ROCKSTREAM DRIVE ASSESSMENT DISTRICT - 2020

CONTRACT NO. 8498

PROJECT NO. 12694

| 12694 | | X-6 | | |

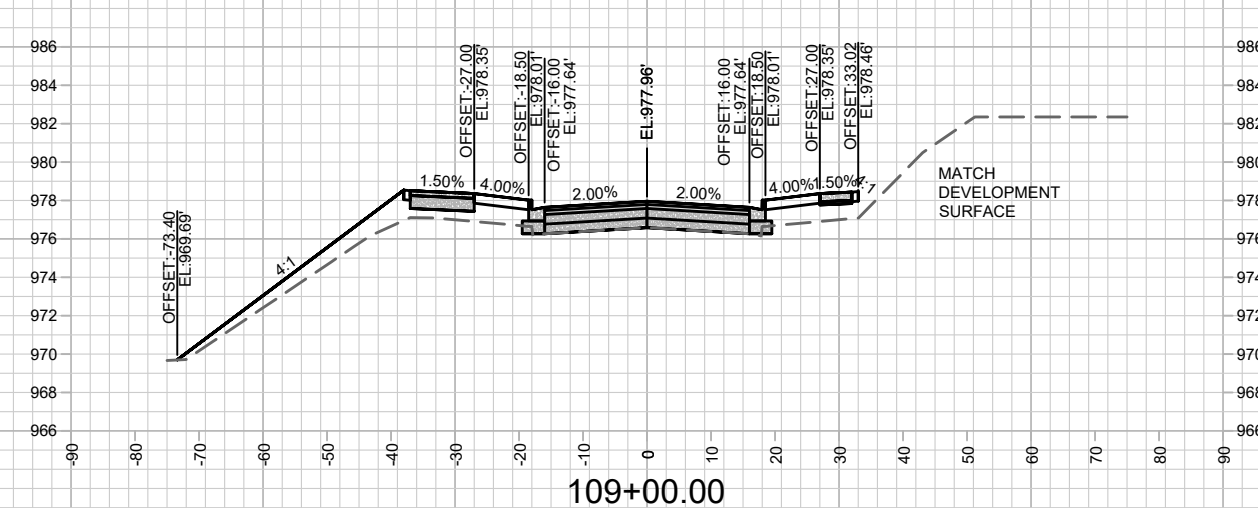
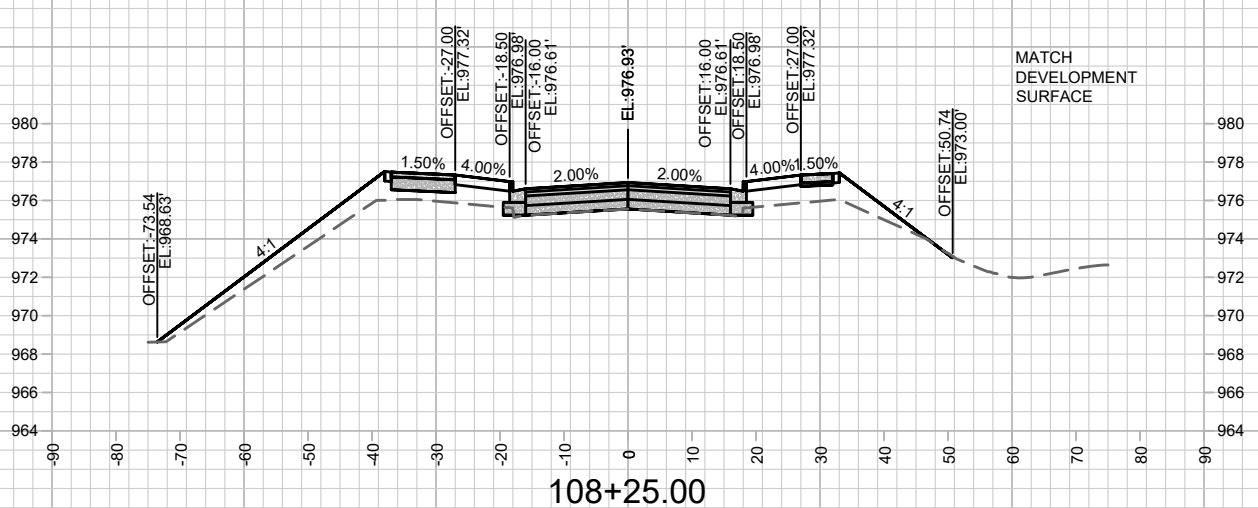
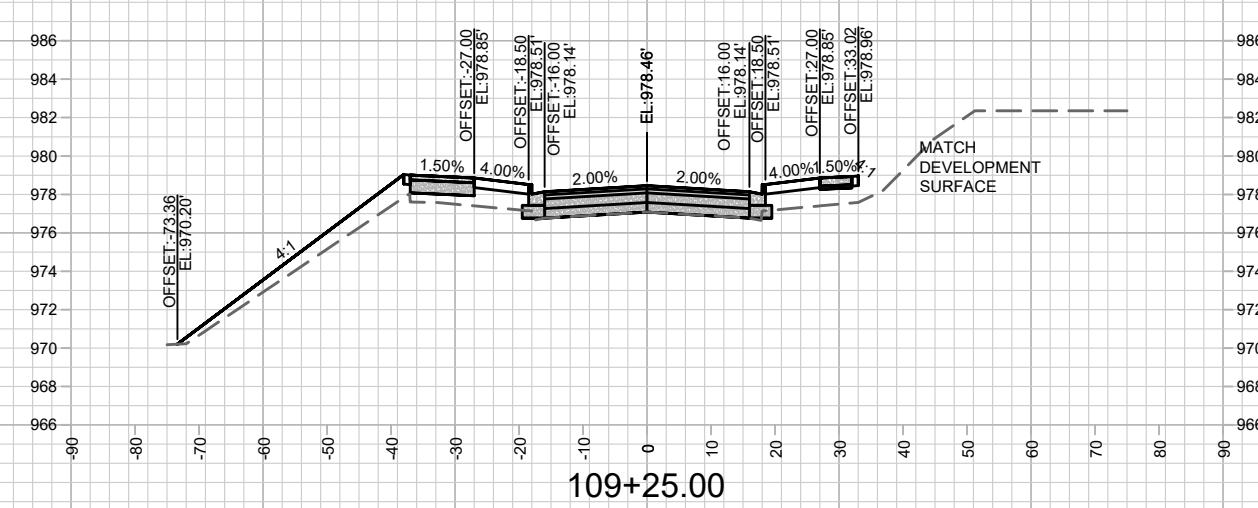
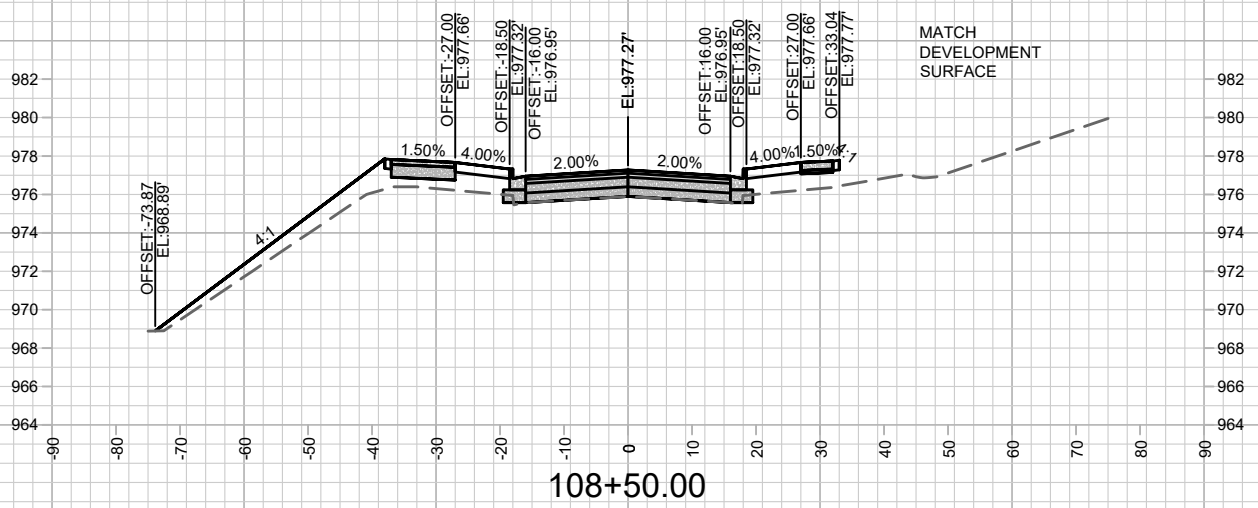
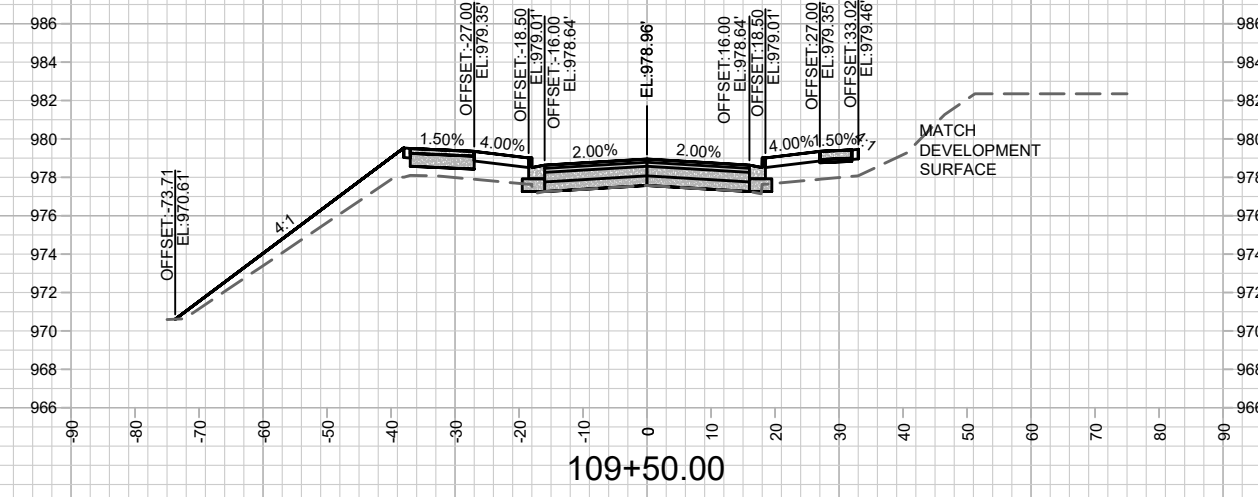
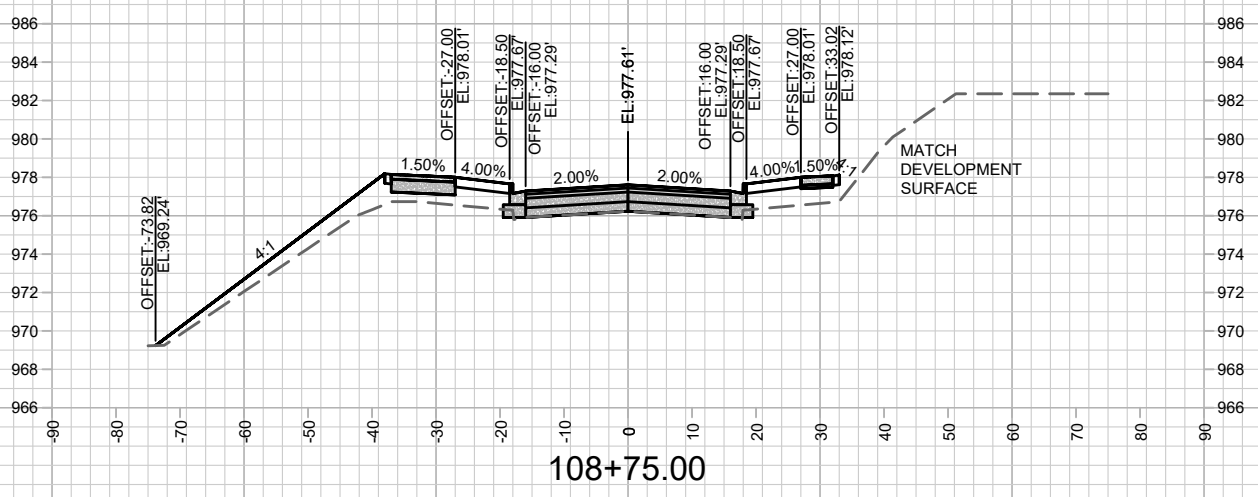
X-5 – X17: Update existing surface to reflect current site conditions.

11-30-2020 REVISION AJZ
 - Updated Existing Surface
